SEWAGE SYSTEM REPAIR

FORM HD-41(73) APPLICATION FOR PERMIT TO ALTER, EXTEND OR REPAIR INDIVIDUAL SEWAGE DISPOSAL SYSTEM

1. Legal description of property: Twp. 12N ; Range 6E ; Section 28 ;
Block _____; Lot _____; Addition 20 Acres
Street Address 1905 W. Davey Rd

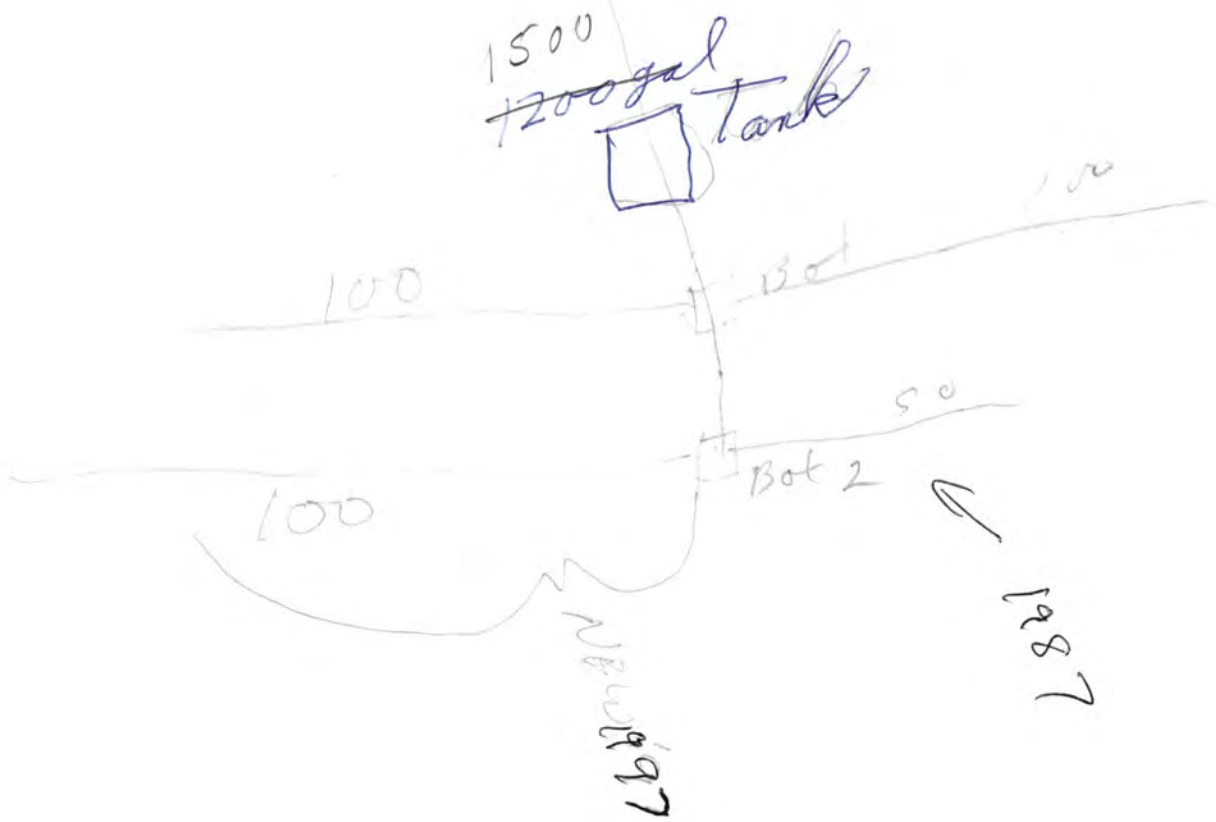
2. Site Visits:
Date: 6-13-97 by: [illegible] (this south run appears to be in Pawnee clay loam)
Date: _____ by: _____
Date: _____ by: _____

(No percolation test was conducted in this area)

Severe limitations because this lateral appears to be in Pawnee clay loam.

Witnessed Percolation test for 1905 W. Davey Rd.

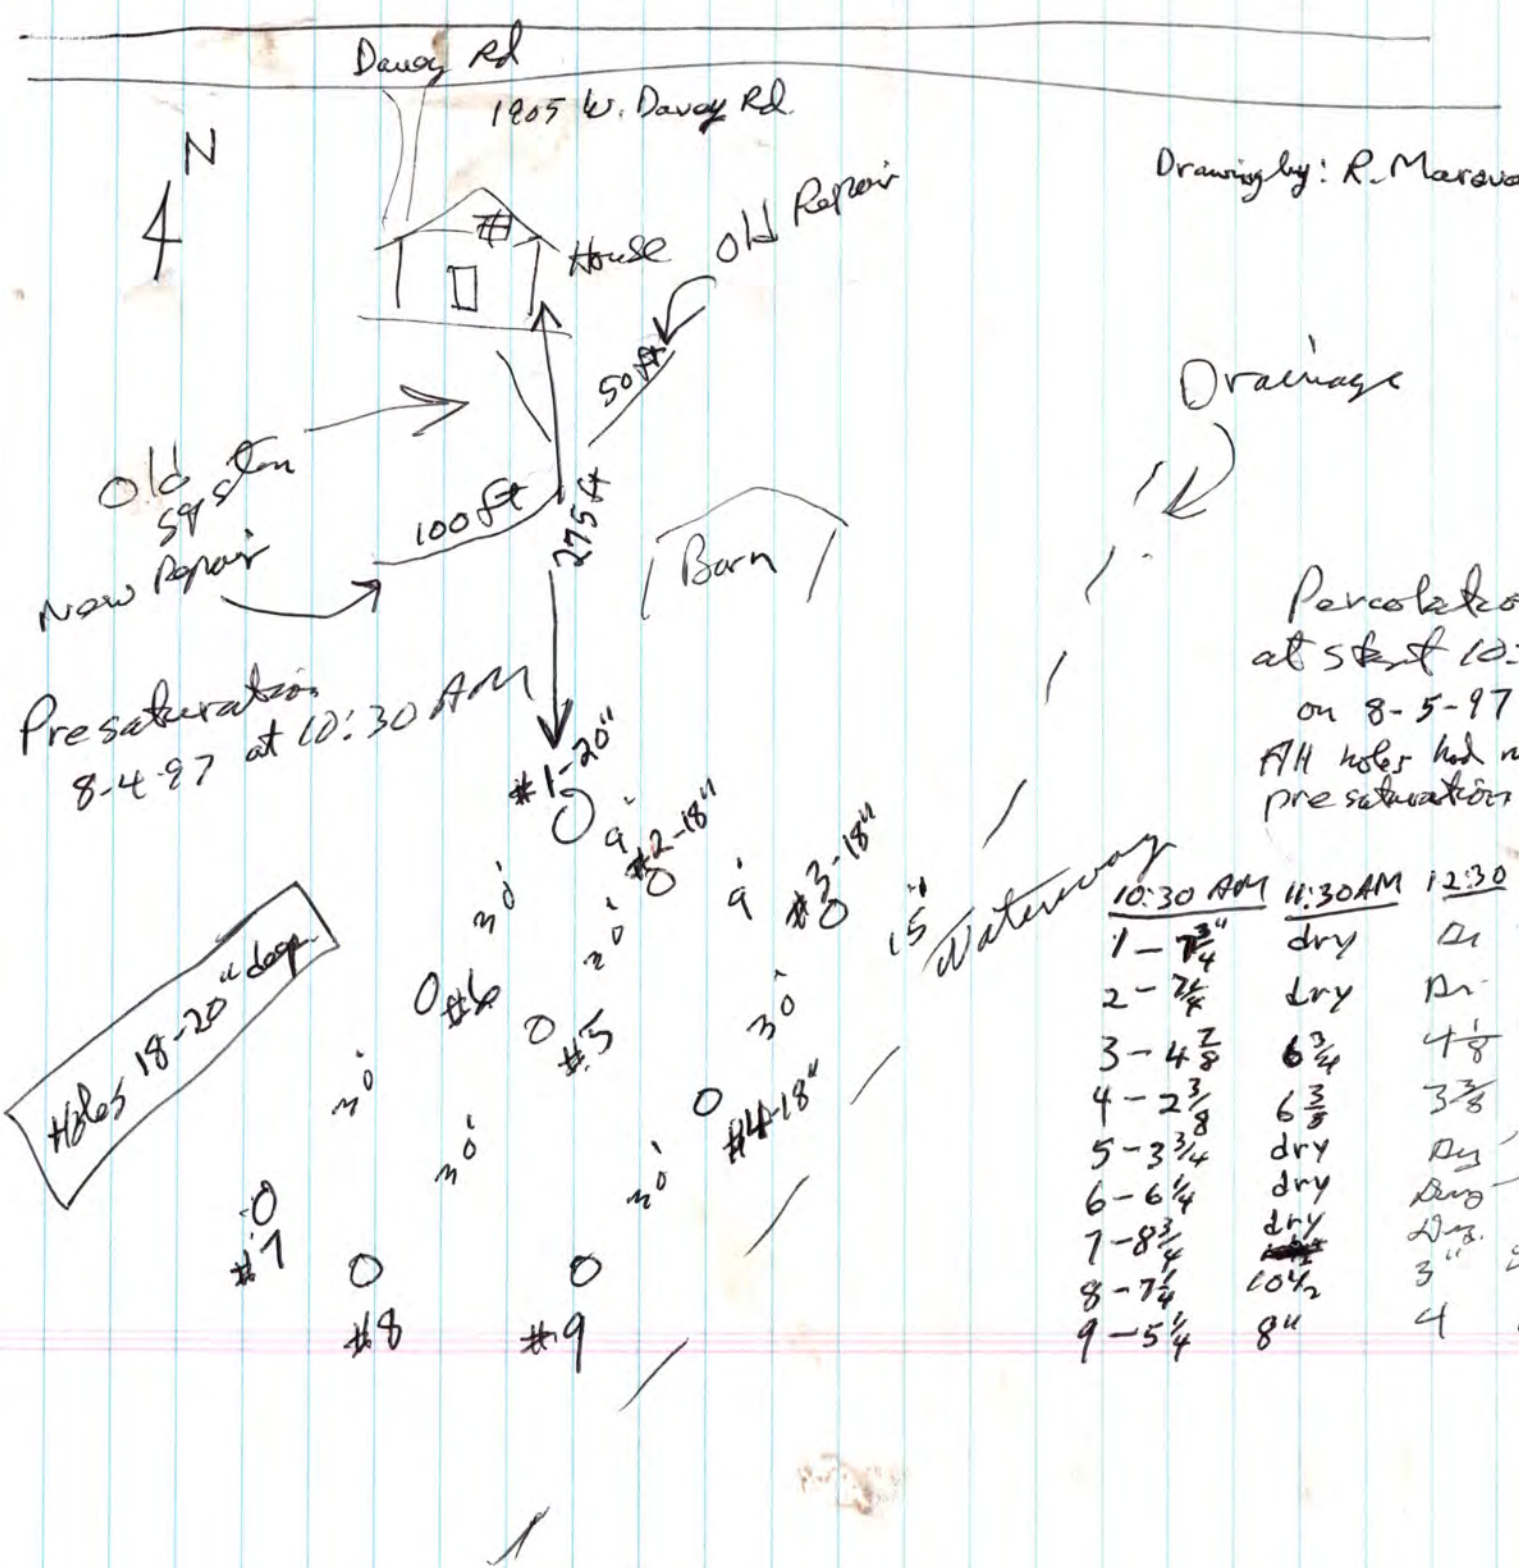
It is the understanding of the LLCHD that an evaluation of the soil be made to prepare for possible future expansion of the present septic system at 1905 W. Davey Rd. Field staff with LLCHD witnessed the percolation test conducted by Harry Sintek. The percolation test passed with a rate faster than 60 min/inch. (The test results and drawing of area in relation to the house are in the file.)

The soil appears to be Shrewsbury silty clay loam as indicated by the soil survey map of Lancaster County.

It should be noted that this percolation test passed at a depth of 18 to 20 inches of soil. The drain field lateral for a future septic system expansion, should it be needed, must be installed at a depth of 18 to 20 inches and no deeper, and in the location indicated on the drawing.
